To Bruce Brunschwig

SERVICE PHYSICS INC.
 P: 650-948-6142 F: 650-948-6143
 TITLE: FLANGE, ADP, S-PROBE
 DRAWING NUMBER: 99017
 SCALE: 1:2

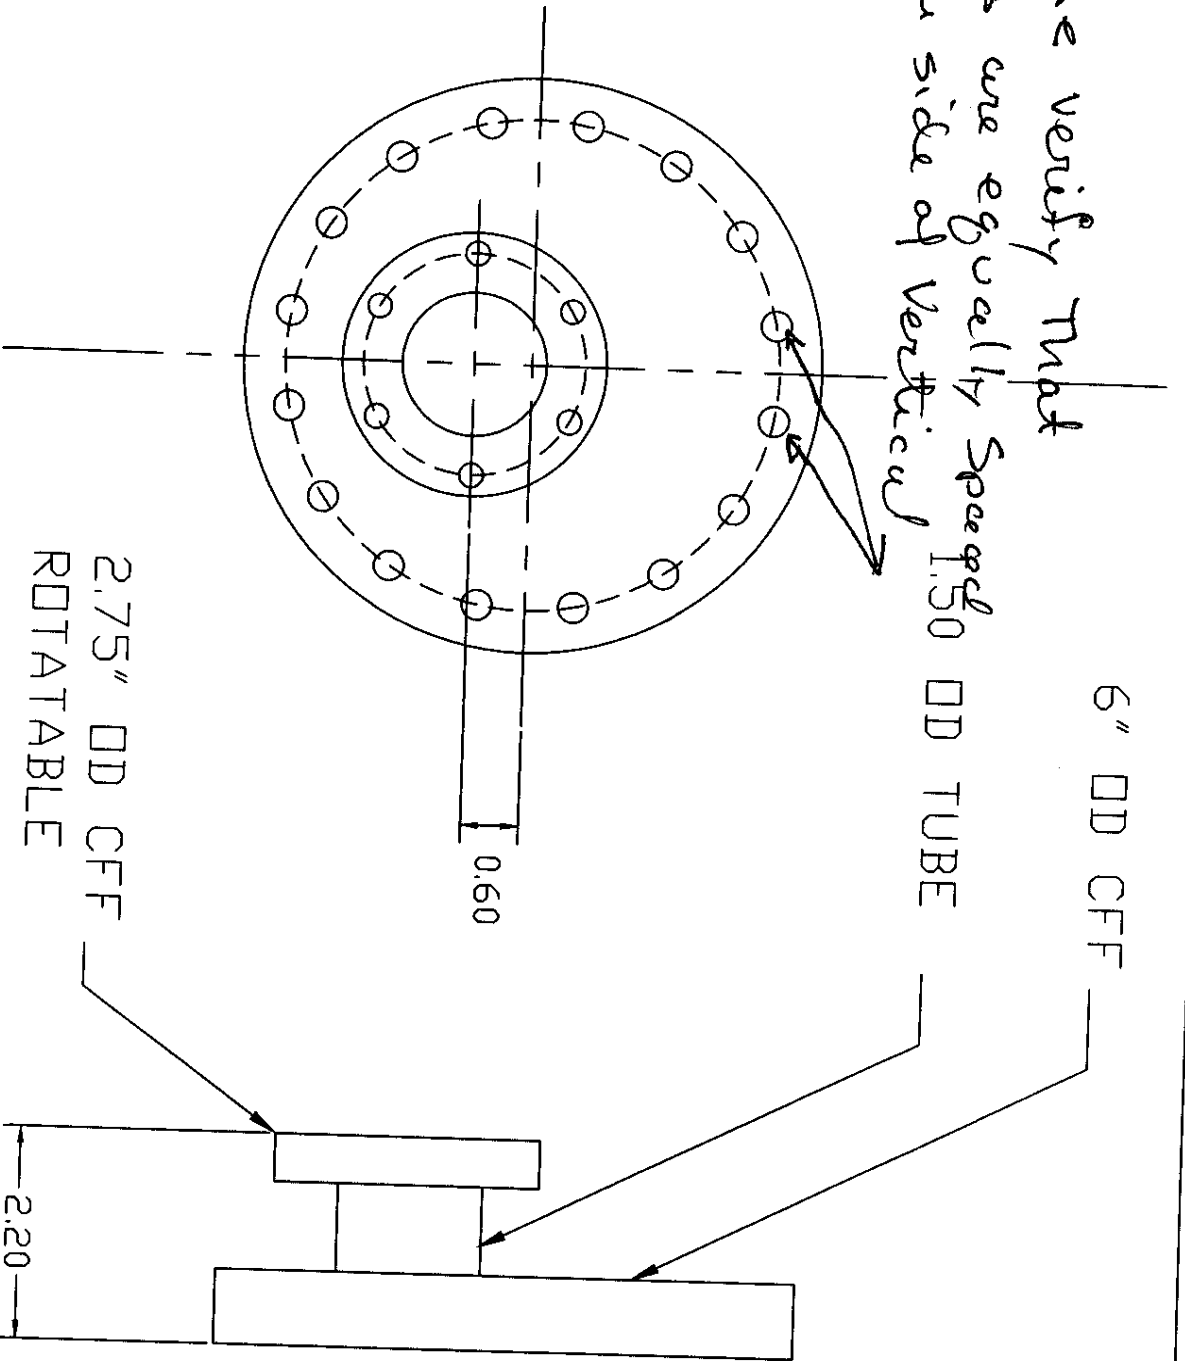
Please verify that
Holes are equally spaced
each side of Vertical
1.50 OD TUBE
